From: Bernard.Collaudin@space.alcatel.fr
Sent: 23 March 2004 08:30
To: Pl's_-_Project_managers@ALCATEL-SPACE.vzmta01.netfr.alcatel.fr;
daniel.santos@isn.in2p3.fr
Cc: Patrice.Couzin@space.alcatel.fr; Rachid.Yakoubi@space.alcatel.fr; Jean-
Philippe.Chambelland@space.alcatel.fr; Guy.Doubrovik@space.alcatel.fr;
Javier.Marti.Canales@esa.int; carsten.scharmberg@esa.int; astrid.heske@esa.int;
marco.cesa@sofiter.it
Subject: Instrument warm units Clock interface
Importance: Low

This mail ref: H-P-ASP-LT-4648

This mail concerns the synchronisation interface between the Spacecraft CDMU and the:

Figure 6-22 : SBDL Interface Details

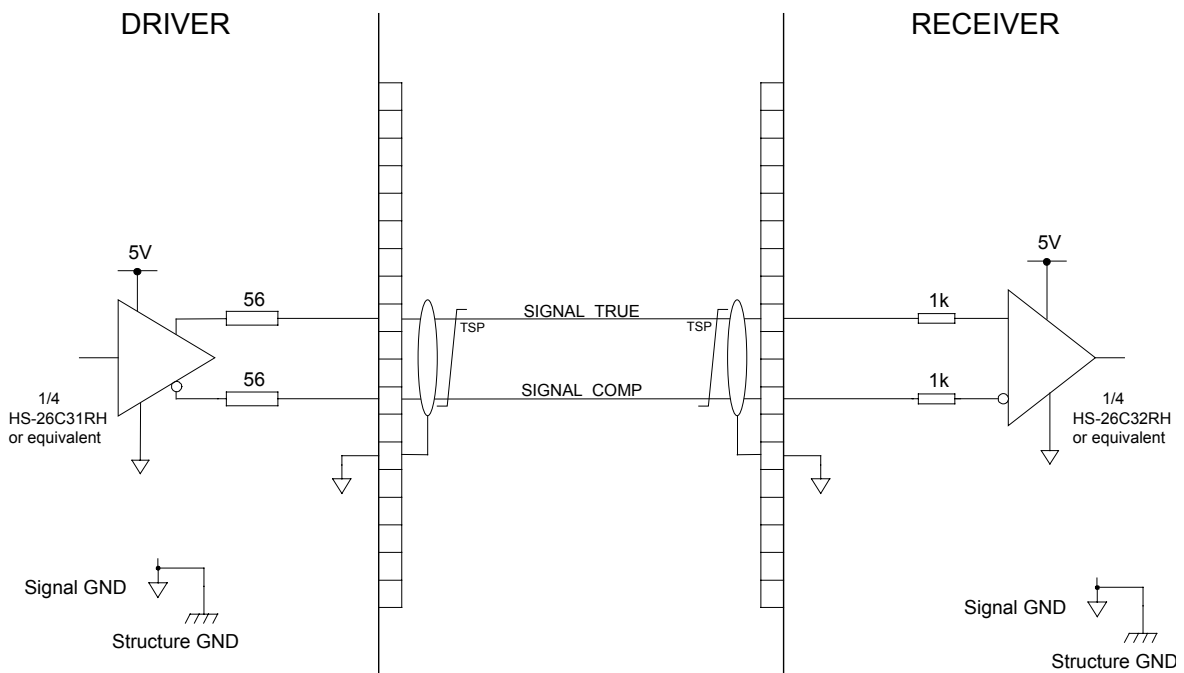
We have received an RFD from the CDMU contractor about the fault voltage tolerance specified in GDIR § 6.8.1.4 "SBDL". Such an SBDL interface is used with some instruments to receive the 131 kHz synchronisation signal.

To assess this RFD properly, we would need to know more precisely how the electrical interface of these concerned instruments is built. More precisely, we need to know the type of the driver used (with its polarisation) to receive that 131kHz signal. Therefore, could you please provide us, as soon as possible, with detailed information related to that SBDL interface ?

The GDIR §6.8.1.4 (RD1 of IID-A, see extract below) requires, for warm units, the use of a HS-26C32RH driver (or similar). Can you confirm that such a component is used in your instrument.
